SUBMITTAL SUMMARY REPORT
33511

PLAN NAME: SR200 & HWY484 MASTER INFRASTRUCTURE **LOCATION:**

OCE: Plan Review (DR) v.1

SHEET NUMBER
C4.0

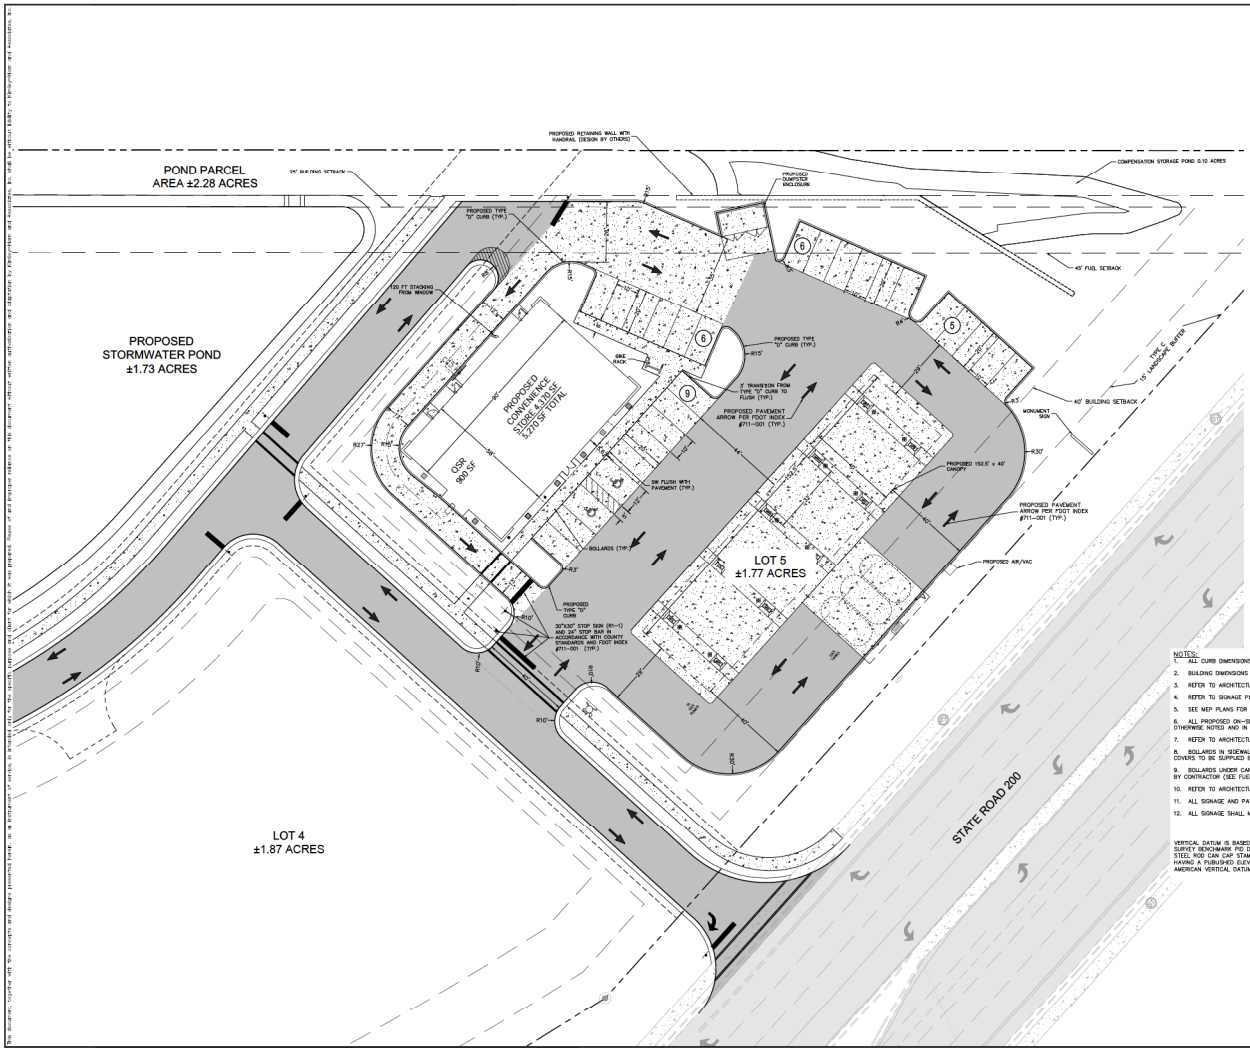
YES 2.12.8 - Legal description matches boundary on plan
NO 2.12.28 - Correct road names supplied Sheets C4.0, C4.1, C6.2, C6.3, L1.00, L1.03, L1.05, L2.00, L2.03, & L2.05 have SW HWY 200 incorrectly labeled as STATE ROAD 200. Sheets C6.2, C6.3, & C6.4 have SW HWY 484 incorrectly labeled as SR 484. Added new road names to sheets C4.0, C4.1, please add to all applicable sheets on all future submittals.
YES 6.2.1.F - North arrow and graphic drawing and written scale
NO Additional 911 comments Address at the top of Sheet C0.0 should be listed as TBD SW HWY 484. The lot layout and road configuration on this Major Site Plan is different than what was submitted on the Prelim.

Corrections	2.12.4/6.11.6 - Construction access (**Not Resolved**) - **Corrective Action:** Please indicate construction access/route on overall site plan sheet. - 2.12.4/6.11.6 - Construction access: Show proposed construction access and route on plan, per Sec. 6.11.6. - Construction access/route,.
Corrections	2.1.3 - Order of plan approval and consistency (**Not Resolved**) - **Corrective Action:** Please note that the proposed lots/layout shown on the Overall Site Plan sheet has not been approved. A preliminary plat (AR 33175) is currently under review. This shall remain a NO until the preliminary plat is approved. A major site plan can be used as a substitute for an improvement plan for the proposed commercial subdivision. Please confirm intention. - 2.1.3 - Order of plan approval and consistency: The plans shall be consistent with approved PUD/Master Plan/Final Plat. Plans listed below may be reviewed concurrently, but must be approved in the order listed below, when applicable and when the proper land use and zoning are in place: A.Master Plan. B.Preliminary Plat. C.Improvement Plan. D.Final Plat. E.Major Site Plan. However, a Major Site Plan can be substituted for the Improvement Plan and can be approved before approval of the Final Plat in cases when the infrastructure improvements supporting the plat are proposed as part of the Major Site Plan application.

Corrections	2.12 - Land Use Designation-adjacent properties (**Not Resolved**) - **Corrective Action:** Adjacent zoning is provided on cover sheet; however, adjacent FLU is missing. Please correct and indicate both on Overall Site Plan sheet. - 2.12 - Land Use Designation-adjacent properties: Show existing land use designation on the adjacent properties.
Corrections	2.12.23 - Building lot typicals (**Not Resolved**) - **Corrective Action:** Please provide lot typicals for proposed commercial subdivision, including minimum lot dimensions/setbacks. - 2.12.23 - Building lot typicals: Show building lot typicals (primary and accessory structures) in table format and illustration.
Corrections	6.5 & 6.6 - Habitat Preservation/Mitigation (**Not Resolved**) - **Corrective Action:** [INFO] If any listed species are observed/potentially located on site, coordinate with FWC and get required permits. Habitat preservation/mitigation plan shall be submitted to County for records at later stage. - 6.5 & 6.6 - Habitat Preservation/Mitigation: Refer to LDC Sec. 6.6 for requirements and design standards if the site contains open water, wetland, listed species, native habitat vegetation, and/or natural open space. When a proposed development or land clearing site is found to include listed species, the application shall identify species and habitat protection as on-site or off-site. The selected option shall be a condition of approval and shall be completed at time of final inspection.

SHEET NUMBER
C6.0

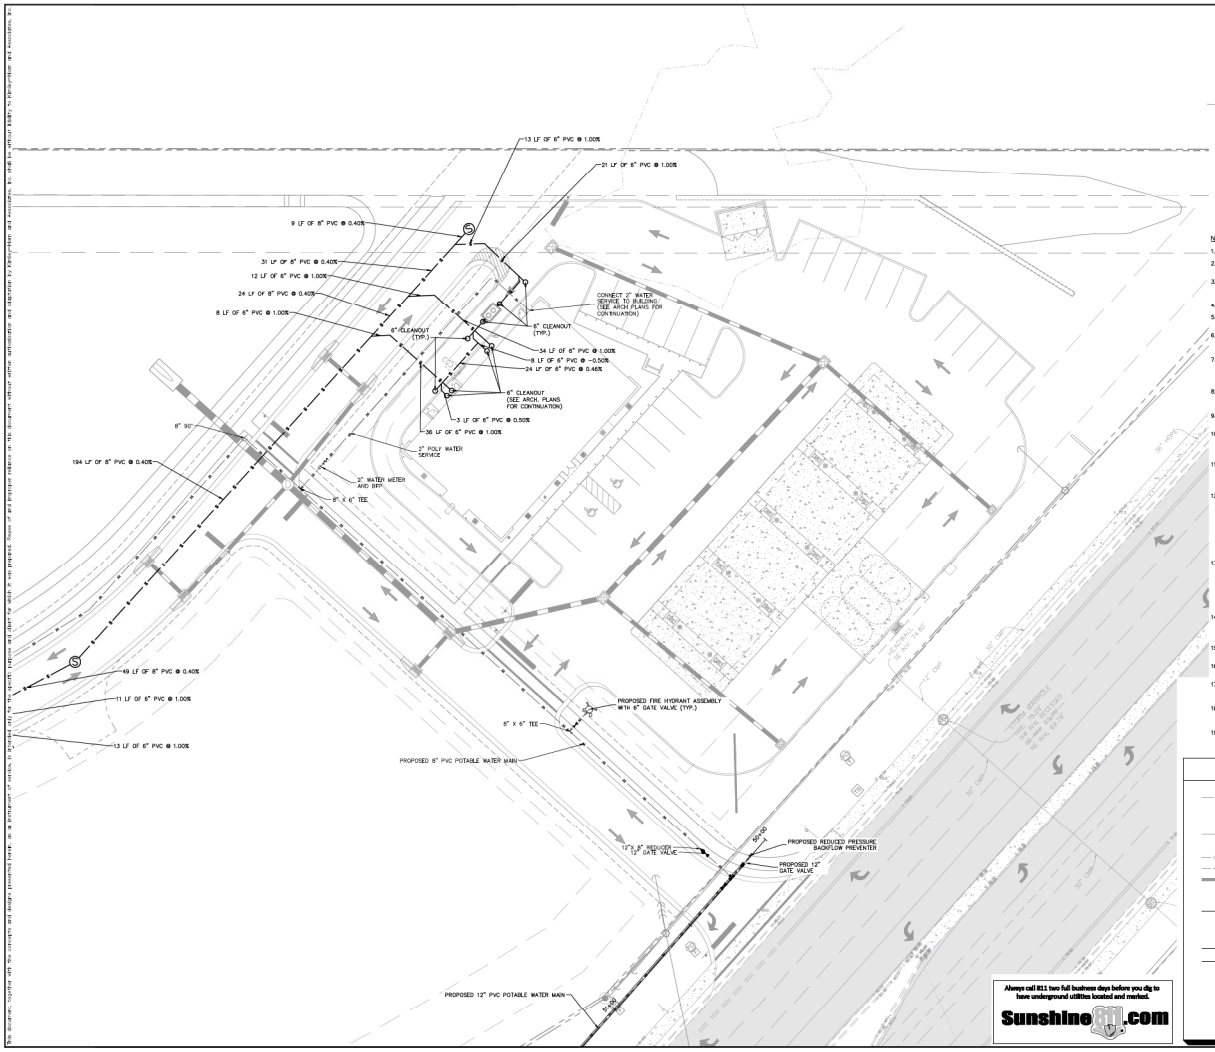
PEND 6.15.9 - Wellfield and Water Supply
PEND 6.15.10 - Water Treatment Plants (WTP)
PEND 6.16.2 - Decentralized Wastewater Treatment Plant (WWTP)
NO 6.16.4 - Wastewater Collection Systems (Gravity/Pressurized) Design C6.0 Design information is needed between S-1 and S-2, and between S-2 and S-3.
No design information has been provided for S-3.
The sewer main should be straight between manholes.
In the SS Structure Table - calculations are incorrect. Please review and revise table including INV's - MH3 is also missing.
PEND 6.16.5.A & B - Private Wastewater Pump Stations
NO 6.16.5.C - Public Wastewater Pump Stations (MCU Standards) C6.2 Notes: The lift station should be identified as public.
Corresponding details and a detail view must be submitted with the next plan review.
The lift station location will need to be reviewed with MCU staff.
The current leader is not pointing to the force main — it appears to pass through it.
